PoE Plus  
IEEE 802.3at  
Classification Ad Hoc  
Extended Classification Using  
Two Classification Events

Clay Stanford  
Linear Technology

January 17, 2007  
Monterey

# 802.3at Classification Using Two Classification Events

# PD Behavior During Mark Event

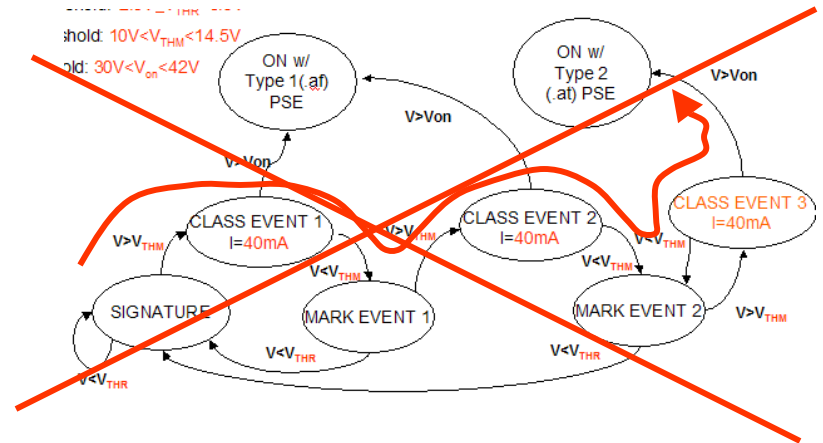
- ~~PD not to present 25Kohm during mark to address non-compliant PSE~~
- Range of PD current limited to ease PSE design task

- ~~PD 2-point signature to be:~~  
 ~~$R_{PD} < 15Kohm$  or  $R_{PD} > 33Kohm$~~
- PD current to be:  
 $0.25mA < I_{PD} < 2.0 mA$
